Response to the 1st Reviewer's Comments:

Figure 6 Seasonal precipitation climatology of ATM.STD, ATM.CPL simulations and observation (CRU version 3.10), along with the corresponding relative biases for the period 1999-2008.

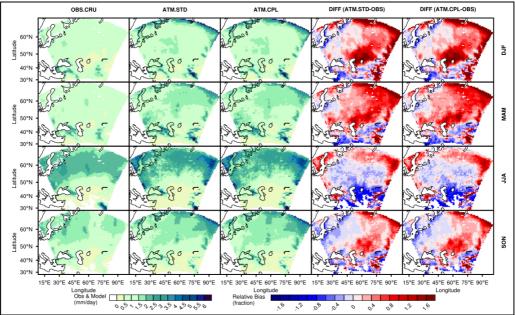
Figure 6 and discussion: I wouldn't plot precipitation bias in an absolute scale, rather the
ratio model/observation - 1 (relative bias). The reason is that precipitation varies a lot,
and small differences can be significant in dry regions but mean nothing in areas were
precipitation is abundant. The precipitation differences you show in Fig.6 are of similar
order of magnitude than the observations, and therefore I wouldn't call the biases small
in the text.

According to your suggestion, we will change the Fig. 6 with the following one. In this case, the plot shows the relative bias rather than the absolute differences. The text in the manuscript will be modified based on this change.
